# TECHNICAL BULLETIN

## Poor Idle Quality – Normally Aspirated AJ16 Engine – Valve Timing Modification

12-57

MODEL 4.0L Normally Aspirated 1995 MY DATE 8/95

ILLUSTRATION 1

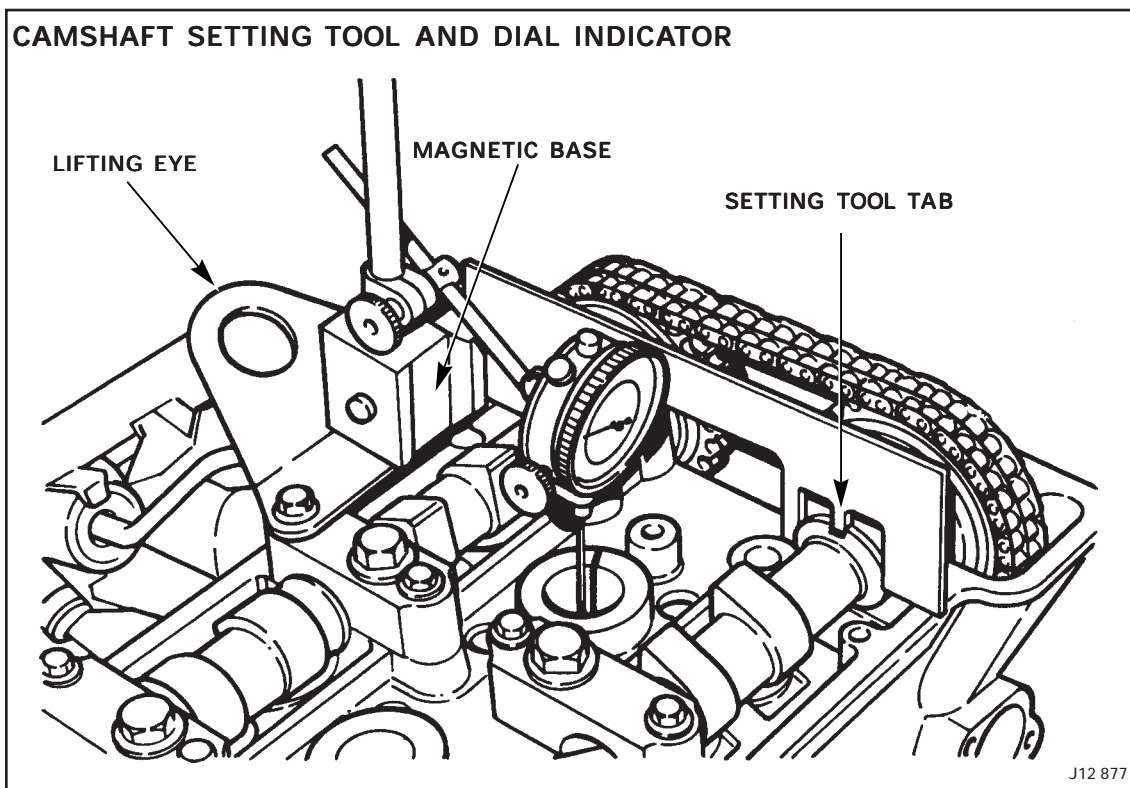
The original camshafts, with a maximum opening position of 110 degrees have been superseded by camshafts with a maximum opening position of 114 degrees. This change is accomplished by machining the camshaft slot in a different

position. The valve timing overlap is reduced from 22 degrees on the 110 camshafts to 14 degrees on the 114 camshafts, Illustration 1.

5. Turn the crankshaft until the No. 1 cylinder is at Top Dead Center (TDC) on the compression stroke, i.e. with the cam lobes on the No. 1 cylinder pointing upwards as in Illustration 1. This position can be checked by temporarily inserting the camshaft setting tool 18G-1433/A into the slot on each camshaft.

7. On all engines, attach an engine lifting eye to the intake camshaft cap as shown in Illustration 1.
8. Position the magnetic base of a dial indicator gauge on the lifting eye.

ILLUSTRATION 2

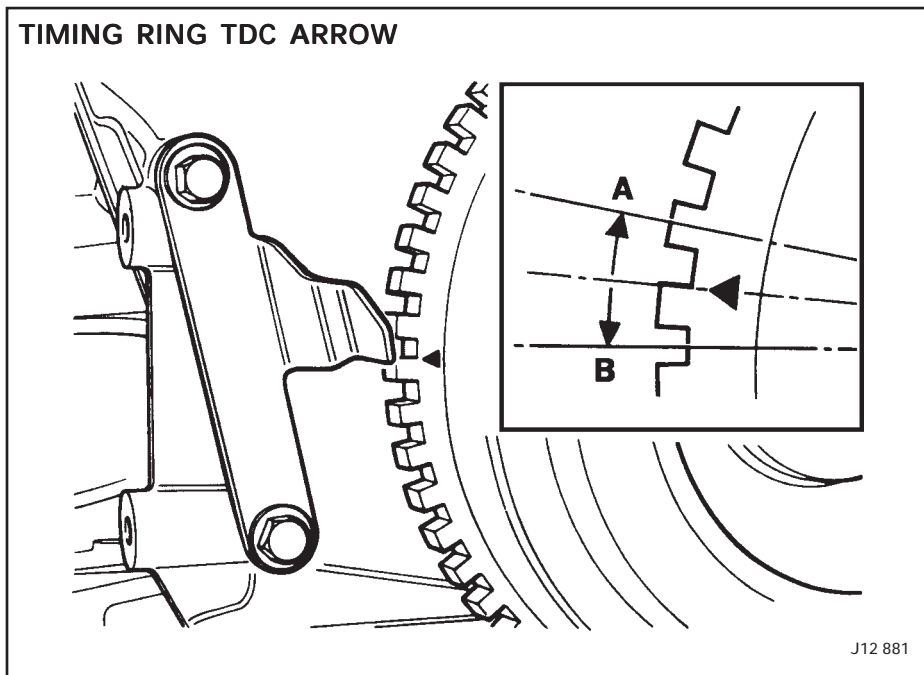
12. Check that the pointer on the front timing cover is in line with the arrowed (TDC) tooth edge on the timing ring, Illustration 2. Realign the pointer if necessary.
13. The crankshaft positions for resetting the camshafts are one and a half teeth on either side of the arrowed (TDC) tooth edge on the timing ring as shown in Illustration 2.
14. Rotate the crankshaft two revolutions in a clockwise direction (viewed from the front of the engine) until the pointer is one and a half teeth before the arrowed (TDC) tooth edge on the timing ring, position A, Illustration 2.

19. Install the locking tabs and the coupling bolts. Lightly tighten the bolts.
20. Remove the setting tool and turn the crankshaft in a clockwise direction (viewed from the front of the engine) until the pointer is one and a half teeth after the arrowed (TDC) tooth edge on the timing ring, position B, Illustration 2.

27. Check both the settings of one and a half teeth before and after the arrowed (TDC) tooth edge on the timing ring, Illustration 2. The tab of the setting gauge should fit in the slot of the camshaft being checked.

ILLUSTRATION 3

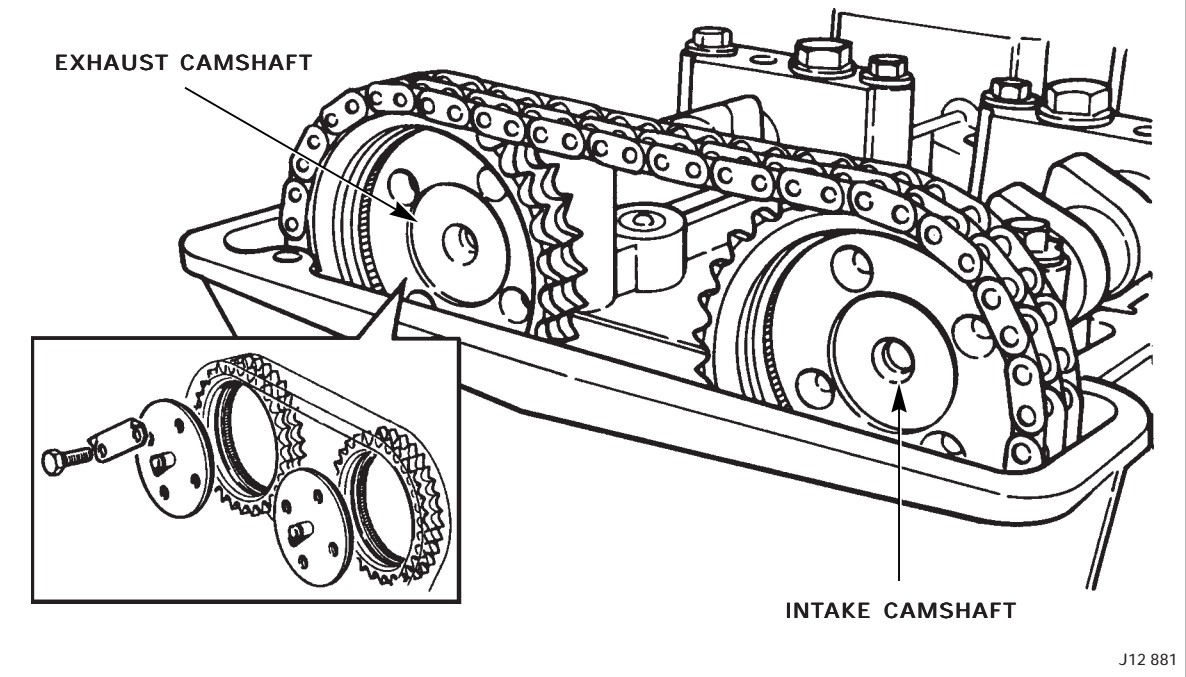
15. Remove the retaining bolts and the camshaft sprocket vernier coupling, Illustration 3, from the exhaust camshaft, but do not detach the sprocket from the camshaft flange. The camshaft is free to rotate inside the sprocket with the coupling removed.
16. Position the camshaft setting tool 18G-1433/A across the camshafts with the positioning tab on the exhaust camshaft, Illustration 1.
17. Turn the exhaust camshaft until the tab on the setting tool engages the slot in the camshaft.
18. With the camshaft in this position, reinstall the sprocket vernier coupling to the exhaust camshaft. This step will require several attempts to find the exact alignment of the vernier splines and the bolt holes.

21. Remove the retaining bolts and the camshaft sprocket vernier coupling, Illustration 3, from the intake camshaft, but do not detach the sprocket from the camshaft flange. The camshaft is free to rotate inside the sprocket with the coupling removed.
22. Position the camshaft setting tool 18G-1433/A across the camshafts with the positioning tab on the intake camshaft.
23. Turn the intake camshaft until the tab on the setting tool engages the slot in the camshaft.
24. With the camshaft in this position, reinstall the sprocket vernier coupling to the intake camshaft. This step will require several attempts to find the exact alignment of the vernier splines and the bolt holes.
25. Install the locking tabs and the coupling bolts. Lightly tighten the bolts.

26. Remove the setting tool and final tighten the camshaft sprocket vernier coupling bolts to 16.2 - 20.6 lb ft (22 - 28 Nm). Bend the lock tabs against the bolt heads.

ILLUSTRATION 4

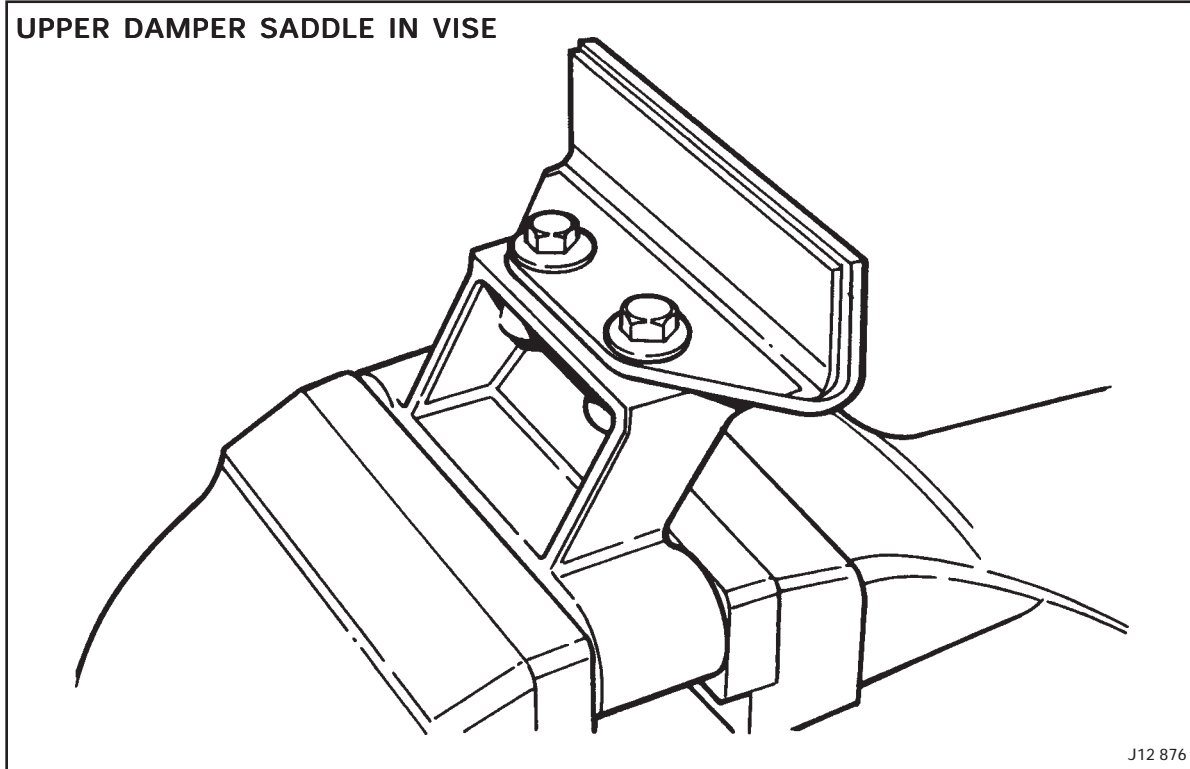
28. Remove the setting tool, the dial indicator gauge, and the lifting eye. Torque camshaft bearing cap bolt to 12.5 - 16.9 lb ft (17 - 23 Nm).
29. On engines with numbers below 9L103934 (XJS Range) or 9J103935 (Sedan Range) only, remove the damper saddle retaining bolts, Illustration 4. Thoroughly degrease the bolts and the saddle. Apply Loctite 545, part number 54531 to the bolt threads and torque to 15.8 - 21 lb ft (21.5 - 28.5 Nm). Install the damper saddle using new cylinder head bolts and torque to 43.5 - 44.9 lb ft (59 - 61 Nm) plus 90 degrees as described in section 2.1 of the AJ16 Engine Service Manual.

**NOTE:** Engines starting with 9L103934 (XJS Range) or 9J103935 (Sedan Range) do not require modification since the damper saddles are equipped with self locking bolts.

ILLUSTRATION 5

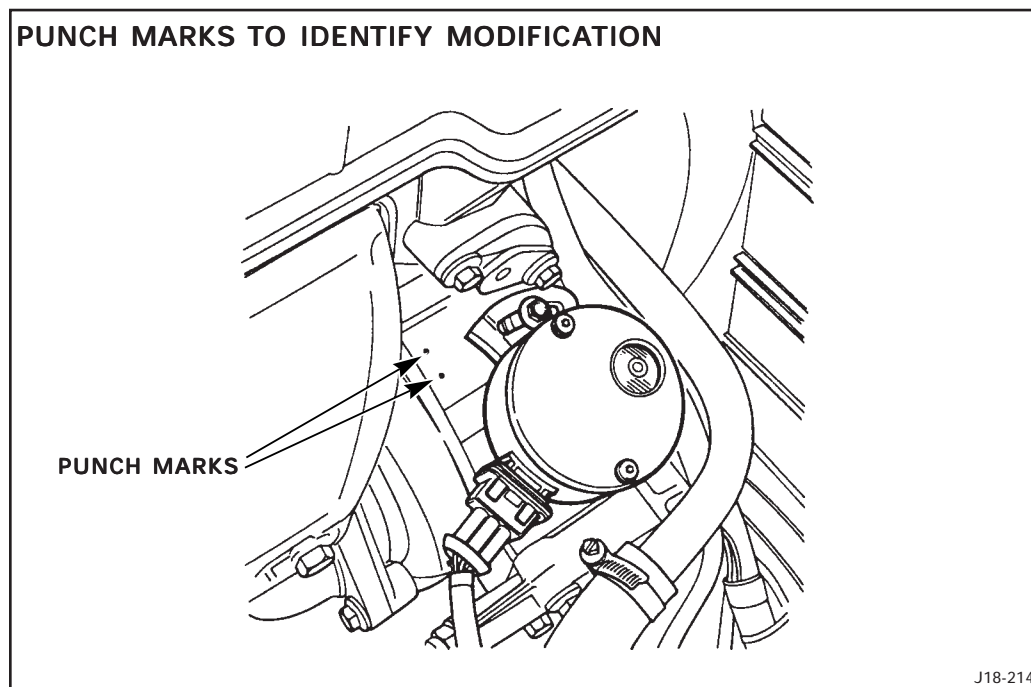
In case of a customer complaint of poor idle quality on a vehicle equipped with the 110 camshafts only, first check for punch marks on the timing cover near the camshaft position sensor, Illustration 5, to determine if the timing modification has already been performed. If not, reset the camshaft timing and spark plug gap as described below.

33. Place two punch marks approximately 1/4 inch apart on the timing cover parallel to the lip, Illustration 5, to indicate that the modification was done.
34. Connect the battery negative cable and reset the clock.
